ADDENDUM to CONTRACT DOCUMENTS

Project Name: Delaware Technical & Community
College Sustainable Energy
Training Center

Subject: **ADDENDUM 4**

STOREFRONT
ELEVATION - SF/10
 Reference: A-401 Drawing: SKETCH-01

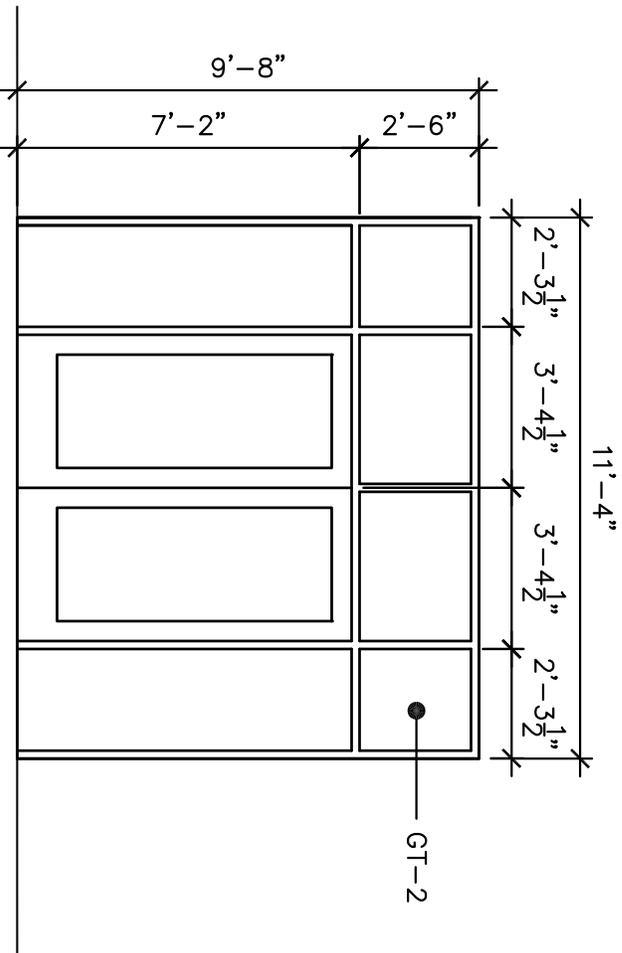
Item No.		Description:
D-1		NEW: A400 – SK-01 Storefront Elevations See attachment

A3	The updated bit form is attached.		
Q4	There was a schedule that was supposed to be distributed. What day can we expect the schedule?	8/28/12	
A4	The construction schedule will be provided with the next addendum.		
Q5	Under remarks on the hardware schedule (A-400) doors 111.1 and 111.2 refer you to storefront SF-10 on sheet A-401, which only has storefront types up to SF-9.	8/28/12	#4
A5	See attached sketch SK-01 for storefront SF-10.		
Q6	Doors 111.1 and 111.2 call for hardware set #1, which in specification section 087100 says "by overhead door supplier". Please confirm the hardware set for these doors or confirm that they are not to be provided by the contractors.	8/28/12	#4
A6	Doors 111.1 & 111.2 are no longer overhead doors and are to be hardware set
